Technical Note

Project: Southern Access Road, Chichester

Subject: Additional Highways Information Review

Client:	Chichester City Council	Version:	A
Project No:	06683	Author:	JS
Date:	20/02/2023	Approved:	AL

Figure 5: Applicant Diagram – Summary of Transport Impact Assessment Methodology

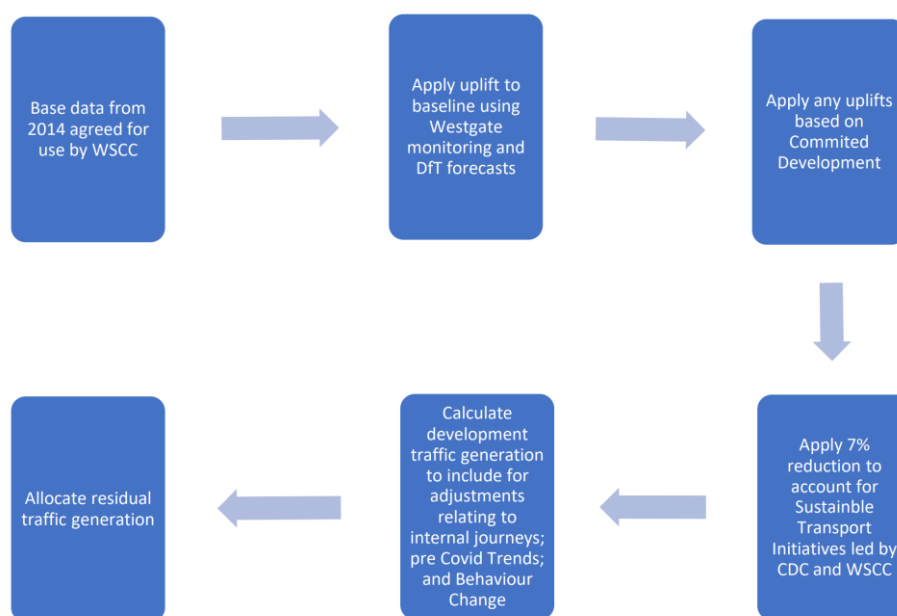
2.3.22 The proposed approach does not consider the requirements for D&P, however on its own could be a reasonable approach had sufficient supporting evidence been provided. Further evidence is required to sufficiently support assumptions made with additional steps included to ensure all effects have been appropriately addressed and that the data is as accurate as possible.

2.3.23 A reduction factor has been applied to baseline trip generation estimates as it has been assumed that policies included within the Local Plan have and will reduce vehicle trips. There may be evidence to support some reduction but this should be presented in the application.

- 2.3.24 Applying a blanket 7% reduction assumes that the policies set out within the Local Transport Plan will be successful and will affect every part of the county equally. This is clearly not the case, and any reductions will be highly dependent on what package of measures would be delivered within the local area.

Figure 6: Alternative Transport Impact Assessment Methodology by PJA

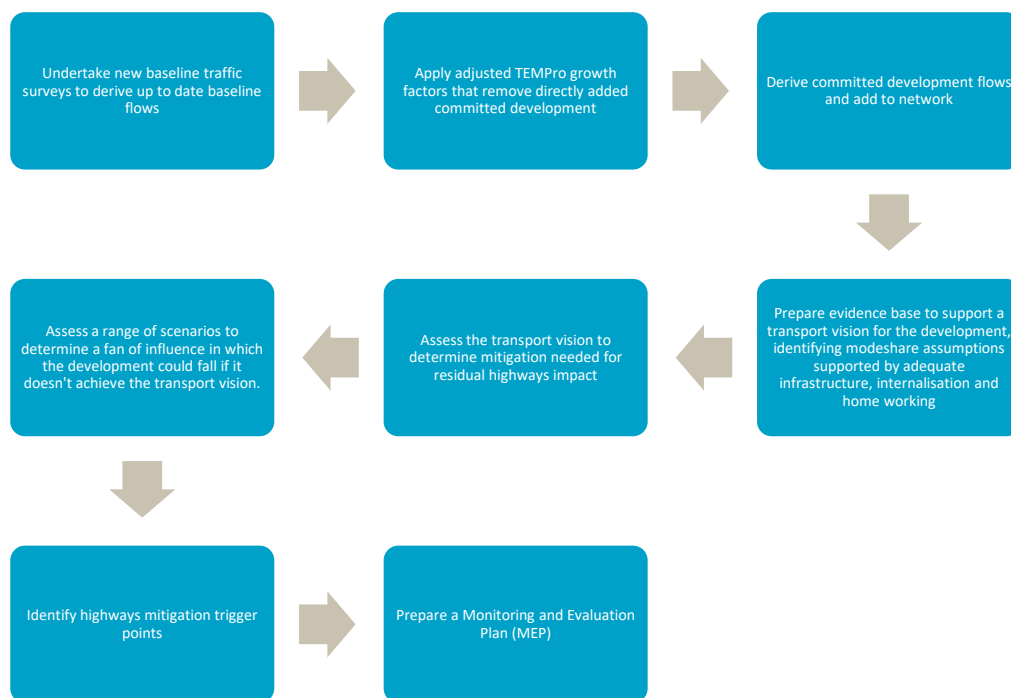
- 2.3.28 Considering these criticisms, PJA have outlined an alternative methodological approach, in Figure 6, taking into account the requirements to achieve the D&P approach. It is urged that this methodology is followed to ensure the suitability of the proposed development and adequately address the concerns raised by the LHA and NH.

2.3.29 The methodology recommend by PJA in Figure 6 follows guidance and incorporates D&P principles, including scenario planning, identification of highway mitigation trigger points and the creation of an Monitoring and Evaluation Plan. It also advocates for the undertaking of new traffic surveys as it is argued that sufficient time has elapsed since COVID-19 restrictions were in place and that travel behaviours have adjusted to a new normal. The methodology would also enable the applicant to consider the impacts of the 7% decrease in vehicular trips but would also identify what would happen under a scenario where a higher or lower shift were achieved and what might be necessary to deliver this.

Figure 13: Paul Wreyford Proposed Arrangement

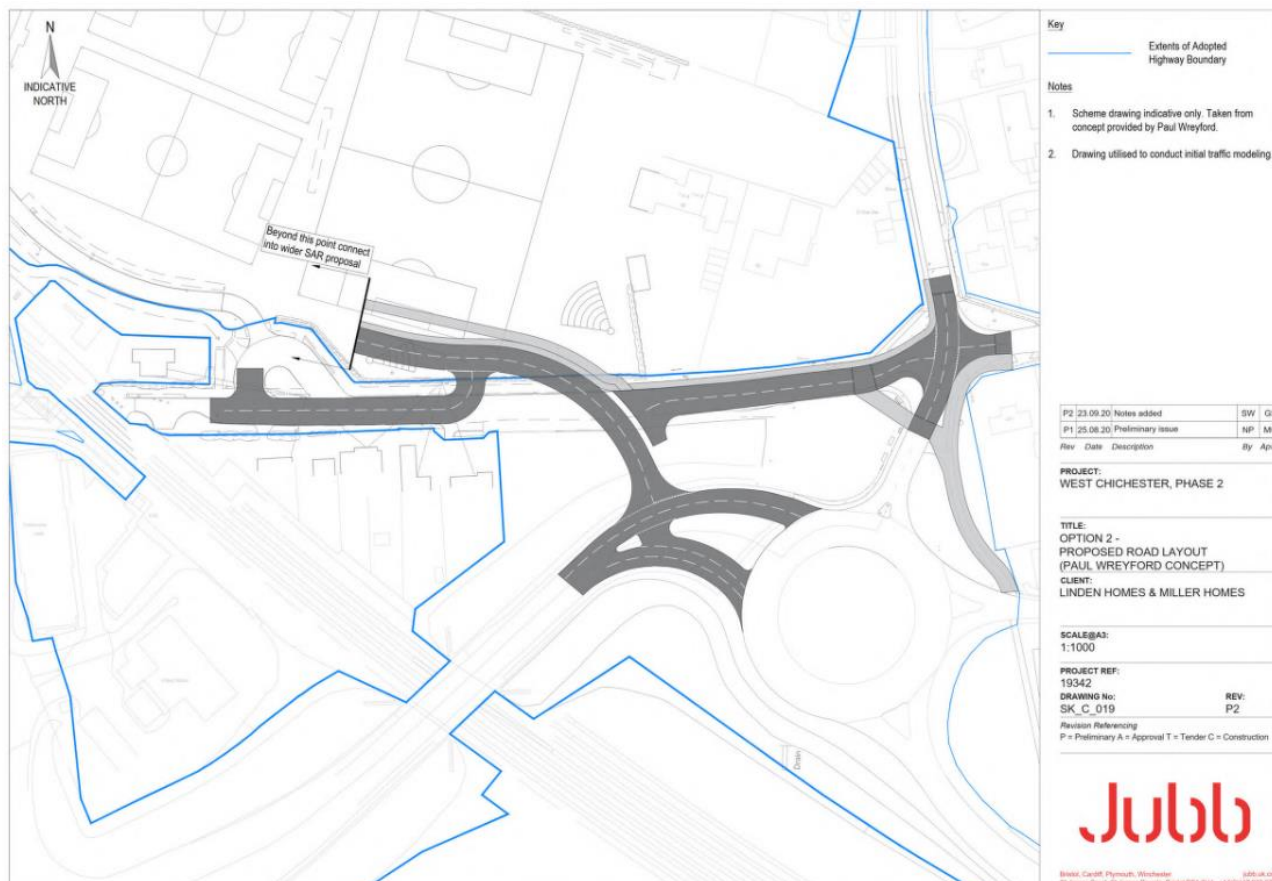
3.1.7 The disadvantages of the proposals include:

- This option was reviewed and modelled within the TA by Jubb and was discounted as the arrangement was anticipated to operate above capacity with associated long forecast queues. PJA have concerns, as outlined within the November 2022 Technical Note, regarding

the traffic flows used within the junction modelling presented within the TA. However, these concerns were only that the level of traffic has been underestimated, therefore, it is believed that this junction arrangement would have capacity issues. Signalisation of the junction could have the potential to overcome the capacity issues, but may raise further issues.

- Signalisation of the junction would result in queuing back from the SAR junction to the Cathedral Way roundabout. Further mitigation would then be required at the Cathedral Way roundabout to address the potential queuing back issue.
- Signalisation could also cause queuing back from the junction to the Fishbourne Road East junction or back to the Fishbourne Roundabout. Queuing back to the Fishbourne Roundabout and on to the A27 would not be acceptable to National Highways.
- Management of queues onto the Cathedral Way roundabout would be required as there would be very limited space for vehicles to queue between the SAR junction and the roundabout entry. PJA would question the practicalities of managing the queues in this way, given the limited space available and potential impacts this may also have on the capacity of the junction.

Figure 14: Indicative Sherbourne Road/Westgate/SAR Junction Modal Filter Arrangements

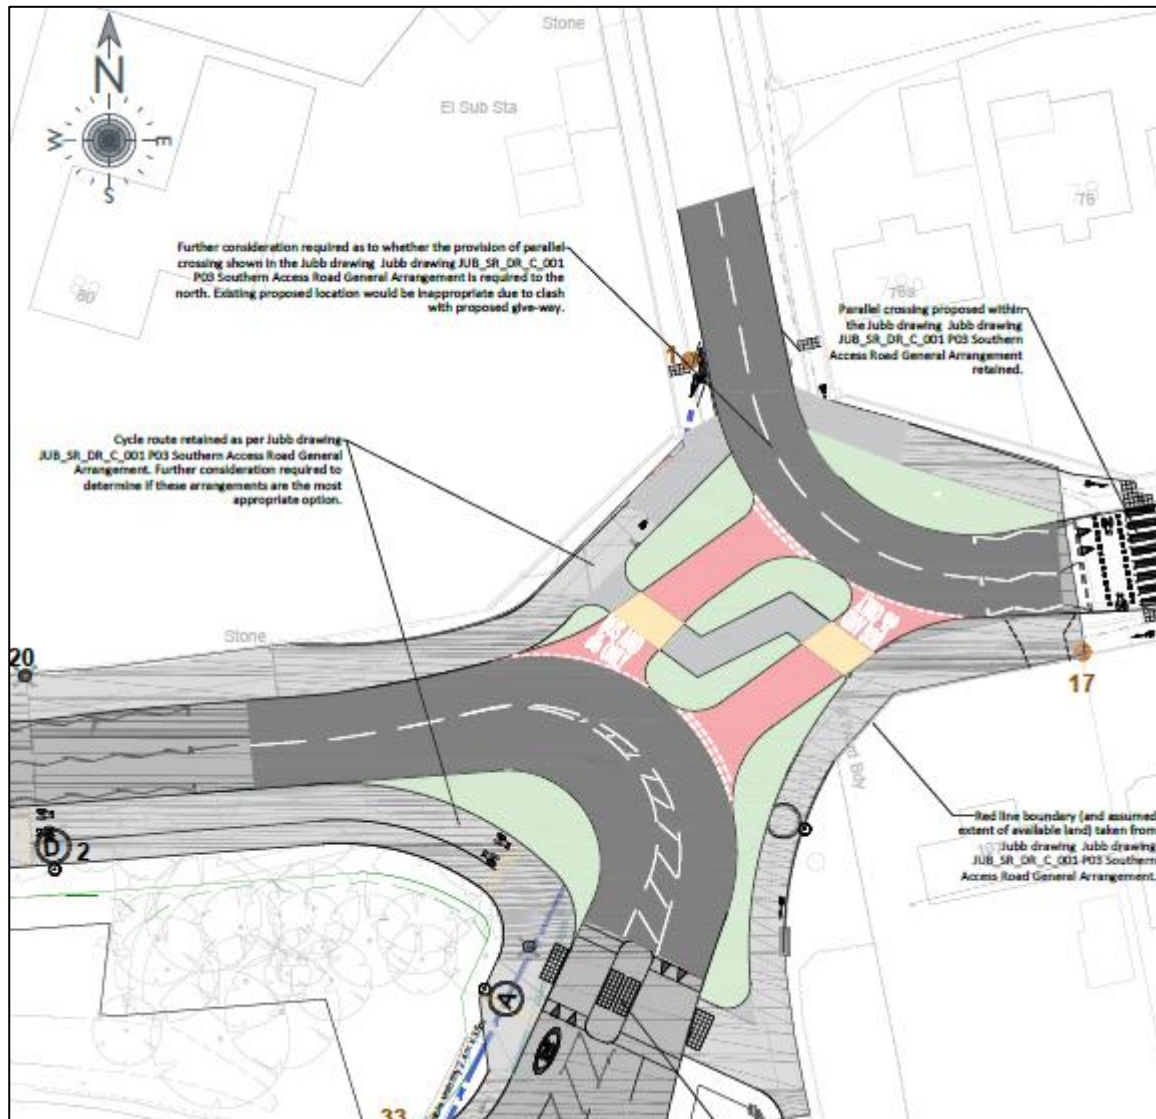
4.2.2 The proposed arrangement consists of a modal filter located diagonally across the junction, although provision remains to accommodate bus movements as buses currently route east-west and south-west through the junction.

4.2.4 The disadvantages of the proposals include:

- Some traffic will be redistributed onto other parts of the network,
 - Through traffic will be primarily redistributed to the A259 and SAR
 - Local traffic to/from A27 will be primarily redistributed via Westgate, A286 and A259
- As has been reported within the November 2022 note, the Local Plan modelling did not consider the potential impacts of the SAR operation as a Relief Road. Therefore, the implications of the SAR operating as a Relief Road would require further investigation.
- Encouraging north-south traffic to utilise the SAR will have a negative impact on the access to the Bishop Luffa School and would increase severance (through increase vehicle flows).

Figure 15: Westgate Modal Filter

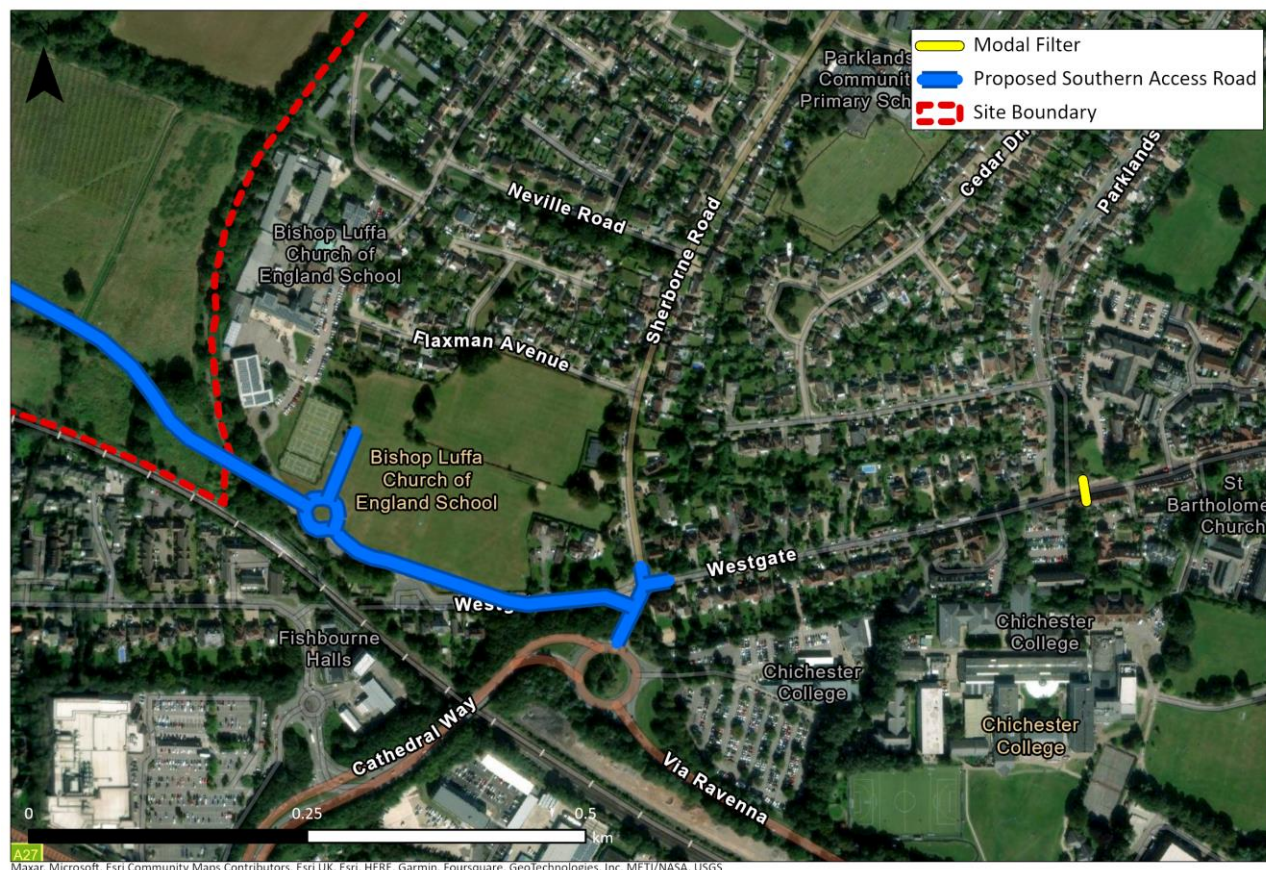
4.3.1 To address the potential effects of traffic redistribution the introduction of a modal filter to the east of the Westgate/Parkland Road junction would ensure that most traffic to/from the A27 can be accommodated with minimal diversion. The proposals are shown illustratively in Figure 15.

4.3.3 The disadvantages of this option include:

- The scale of traffic reduction on Westgate (to support a mixed traffic cycle route) would not be as great.
- The SAR offers limited benefit to adjacent communities.

- The turning movements at the SAR junction require a carefully considered junction arrangement

4.3.6 If WSCC/NH are minded to support a monitor and manage approach it seems reasonable to identify a mitigation package based on the cost of delivering a modal filter as shown in Figure 15 and junction improvements based on Figure 16 and updated traffic forecasts.

Figure 16: Potential A259/SAR Junction

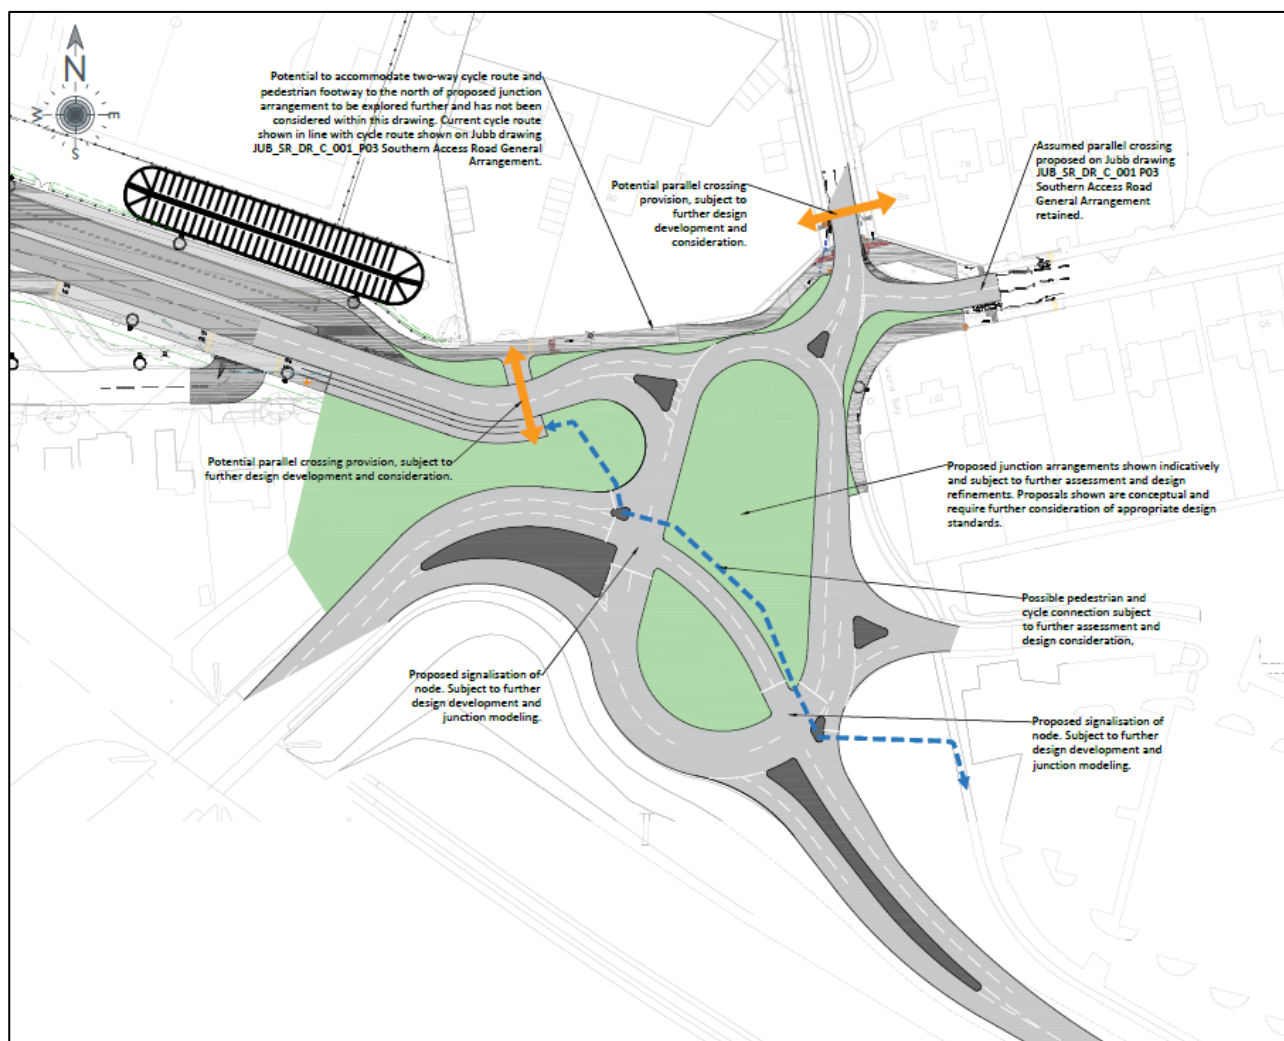
4.3.4 Responding to the scheme disadvantages it is likely that a more complex SAR junction could be necessary to respond to the A259 Westgate Link (College) Roundabout, as identified in the Local Plan evidence, shown illustratively in Figure 16 and in the drawing provided in **Appendix B**.
